**[EXTERNAL] Beatrice Buck Park Historic Review**

I am writing on behalf of the Music Hall Center for the Performing Arts (MHCPA) with my comments regarding the Beatrice Buck Park improvements.

One item we would like to see revised in the current design is the northern tip of the Beatrice Buck Park, where Randolph Street and Grand River Avenue meet and become a single street leading to Madison Avenue.

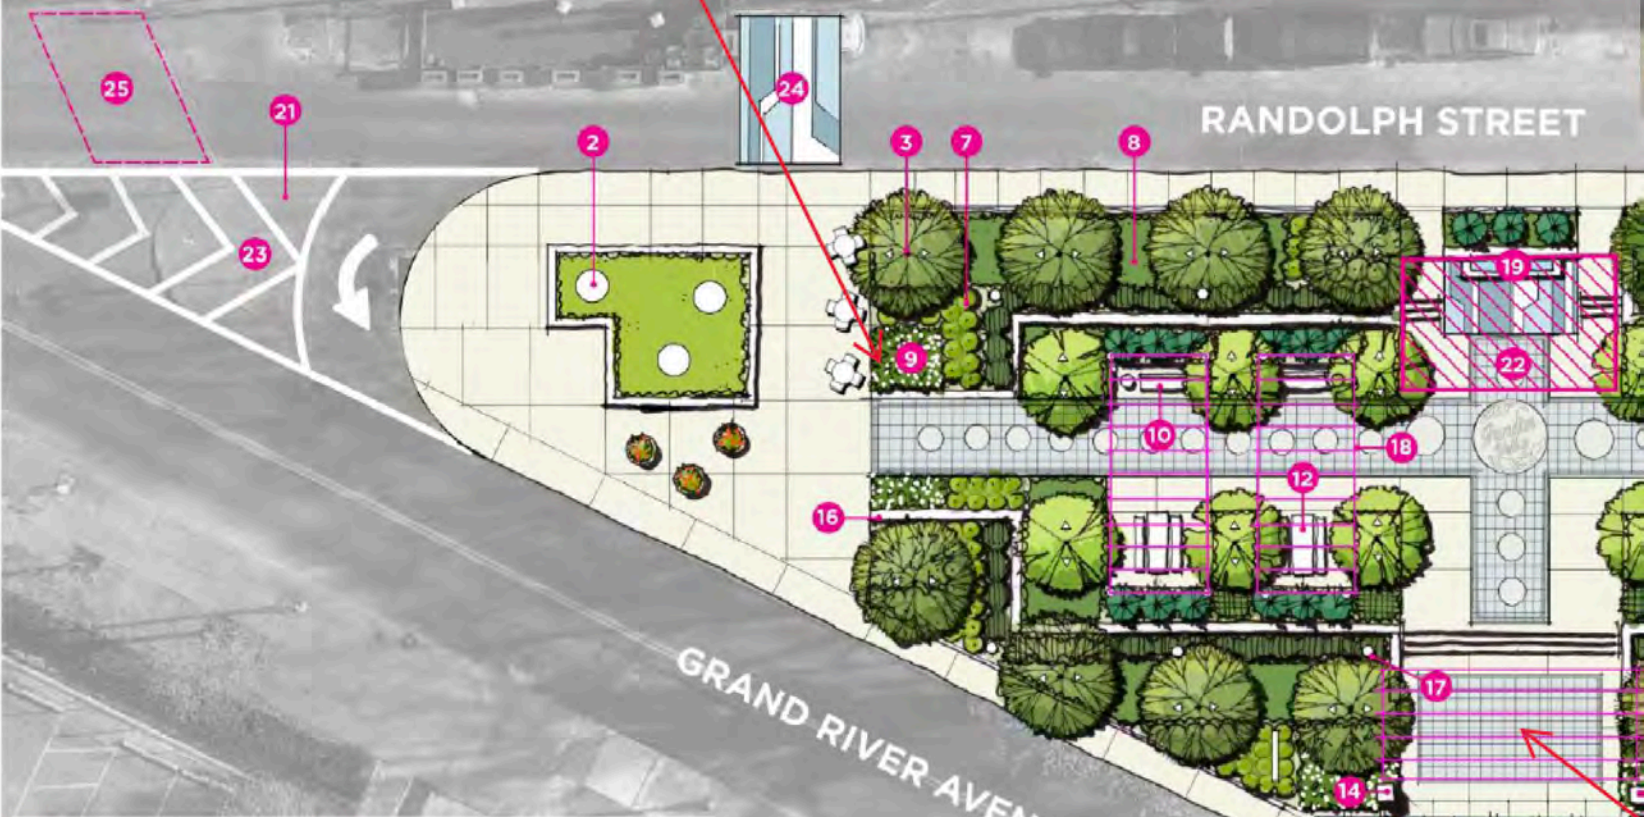
In the original concept sketches presented for the PPR Review, Progressive had proposed to cut back the existing sidewalk as well as a portion of the existing planter bed to create a "turning lane" from Randolph to Grand River.

During the course of the Design Development and Construction Drawings, this cutting back of the planter and sidewalk was eliminated and the existing conditions were not changed.

We would like to have it noted on the record that we favor the earlier solution with the cutting back of the sidewalk and planter bed. This will facilitate access to the new loading dock drive on Randolph in the MHCPA expansion. Without the cutback, there is a strong chance that trucks will drive over the sidewalk to access the loading drive entrance and potentially damage the sidewalk and planter bed.

The original turning lane addresses a condition and problem that occurs now where vehicles have to make a very sharp turn and are essentially dis-obeying the vehicular striping at the tip of the park. Besides creating a safer condition for both vehicles and pedestrians, the cutback to create the turning lane would provide access to the new loading dock drive entrance.
